Building Permit Application

RE: CTOL 1, 14905 Victory Ln

STORMWATER MANAGEMENT PLAN LOT 1 MERIWETHER FARMS LIBER 13779, FOLIO 473

SHEET DESCRIPTION FIRST FLOOR PLAN

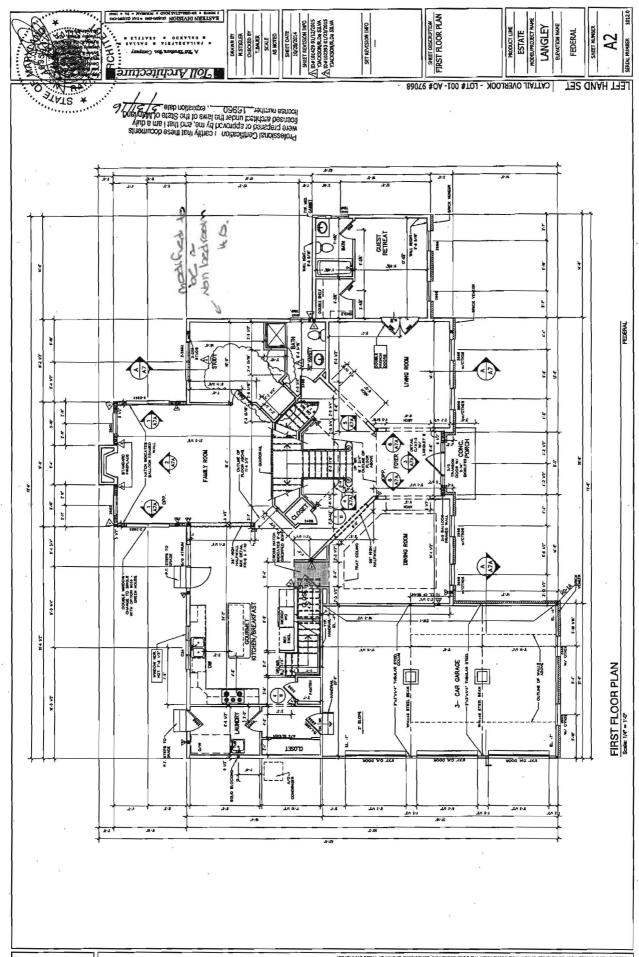
Attached please the definition of a bedroom (Subtitle 8 Sec 3.801 (b) Bedroom). A bedroom is not solely defined by closet space. For this room not to be a bedroom, you could widen the door way to 4 feet and remove the doors, make the adjacent bathroom a half bath or construct permanent built in bookcases around the entire room.

I did receive a copy of the first floor plan. It doesn't appear to be any different. It still shows the room now called the "Study" with direct access to a full bathroom.

Hank, Just wanted to touch base and make sure you got the new floor plan for this home? We changed the first floor bedroom back into a study, leaving the guest retreat alone, taking us to 5 beds. Let me know as you guys are the last piece of my puzzle for permit. Thanks

(iv) The room is a first floor room or basement area that does not have direct access to full bathrooms or "roughed in" plumbing that would provide direct access to future full bathroom facilities.

Michael – Looks good as shown. Please submit several copies of this revision to D.I.L.P. DILP should in turn forward a copy to the Health Department.

Hank- attached is the revision to the plans on lot 1: 14905. We have removed the door that had direct access to the full bath per the code description you sent to Jason.
